## **REGULATORY INFORMATION DISTRIBUTION SYSTEM (RIDS)**

SUBJECT: Forwards addl info re response to reactor coolant pump tripping strategy issue, per NRC 880824 request.

Subject: Palo Verde Nuclear Generating Station (PVNGS)  
Units 1, 2 and 3  
Response to NRC Request for Additional Information - Reactor  
Coolant Pump Trip Strategy  
File: 88-A-056-026

**ATTACHMENT - ANPP RESPONSES TO NRC QUESTIONS**

**FIGURE 1  
SINGLE LINE DIAGRAM**

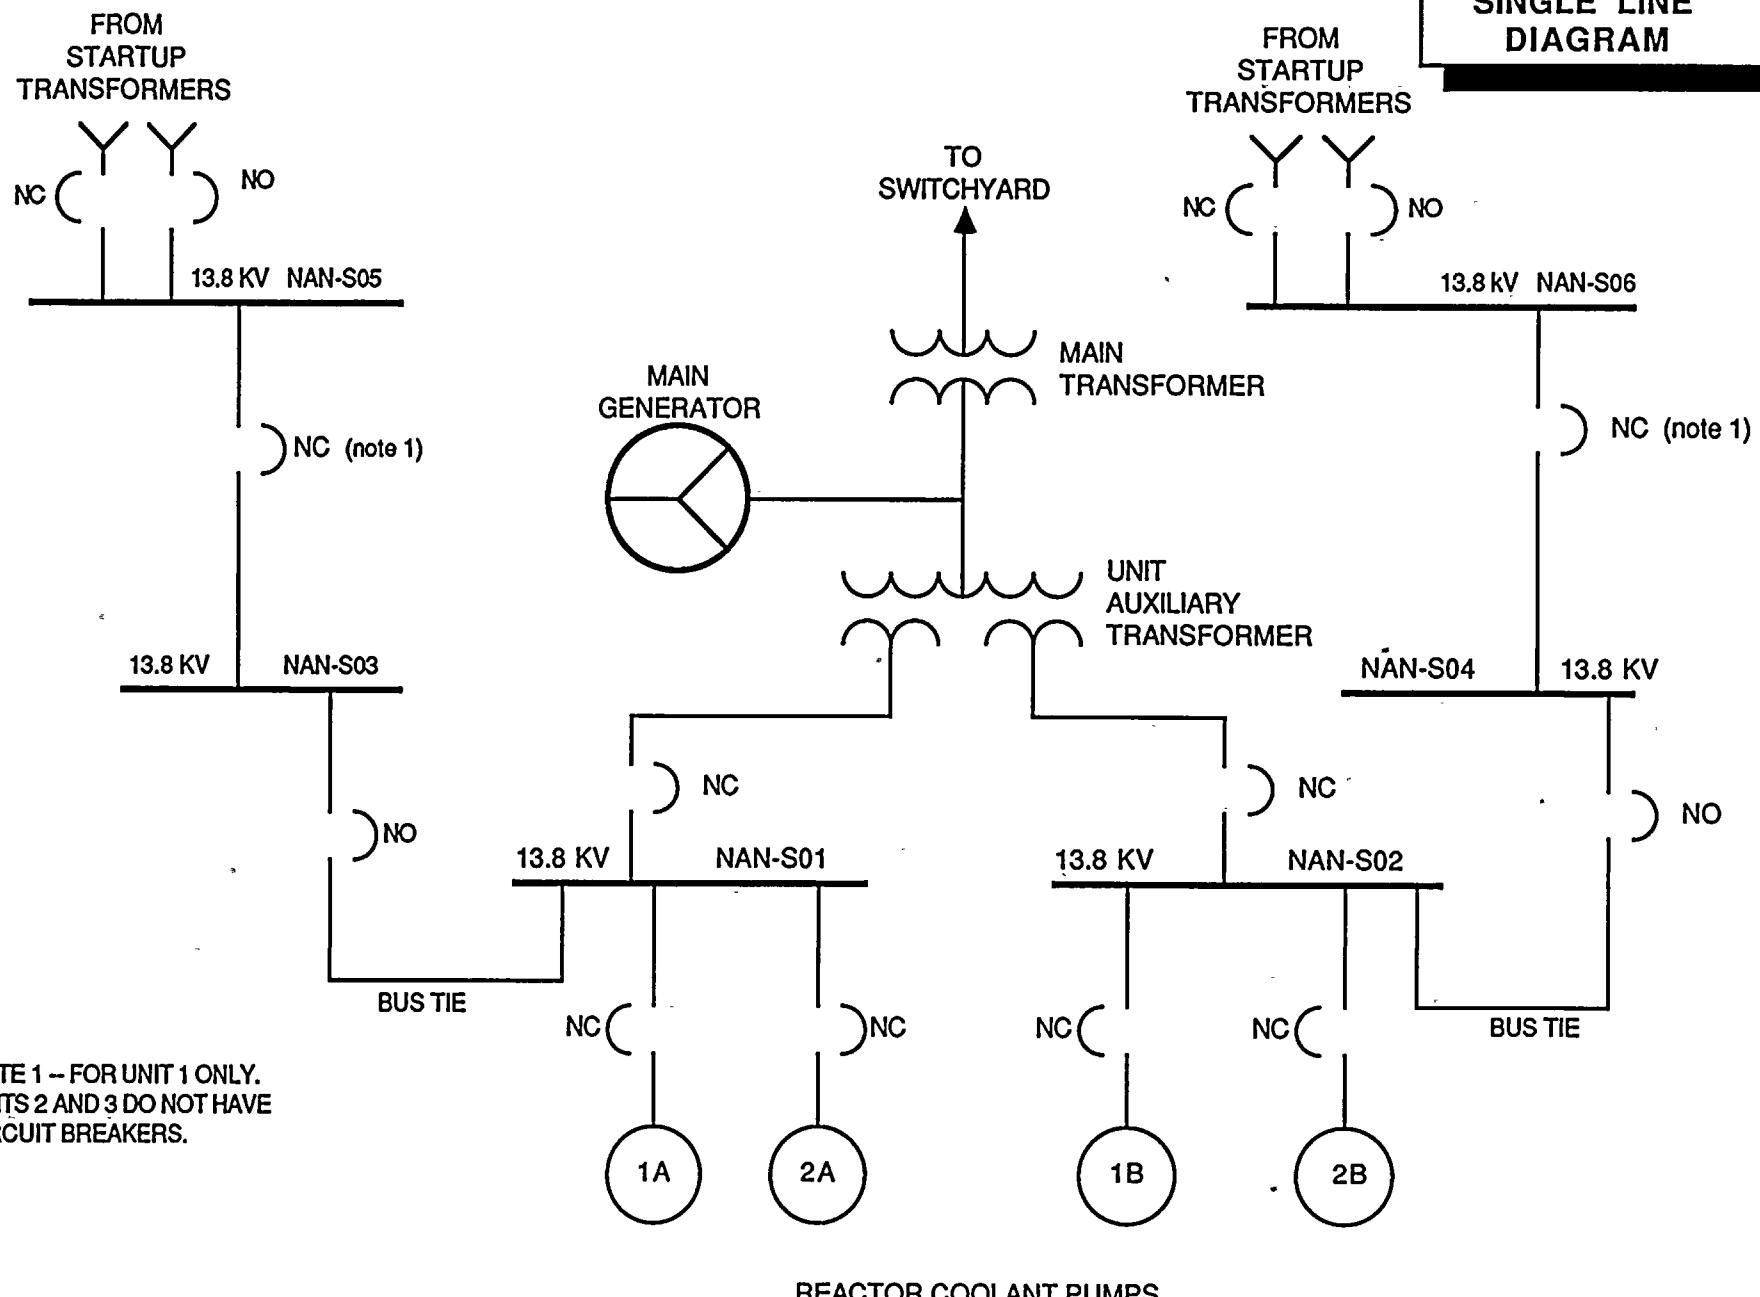
- a. Identify the components required to trip the pumps. Include relays, power supplies, breakers, or other equipment. Address equipment reliability, alternate trip methods, and operator training. How much time are the operators allowed to try and trip the RCPs from the control room before they use an alternate trip method? How much time is required to travel to an alternate trip location?
- b. If necessary, as the result of the location of any critical component, include the effects of adverse conditions inside or outside containment on RCP trip reliability. Describe the basis for the adverse conditions selected.

The four RCPs receive power from two separate non-Class 1E busses. RCPs 1A and 2A are fed from 13.8 kV bus NAN-S01 while RCPs 1B and 2B are fed from 13.8 kV bus NAN-S02. Figure 1 shows the power supply arrangement for the RCPs. The 13.8 kV switchgear NAN-S01 and NAN-S02 are physically located in the switchgear room at the plant southwest corner of the turbine building (i.e., the corner of the turbine building closest to the control building as shown in Figure 2). The switchgear room is located at the grade elevation. As described in the following paragraphs, the RCPs can be tripped locally at the breaker. The breakers for the RCPs are located in the switchgear room. The switchgear room is considered a mild environment that should be accessible at all times during accident situations. If necessary, an operator can be sent to the switchgear room to open the RCP circuit breakers. Due to the proximity of the switchgear room to the
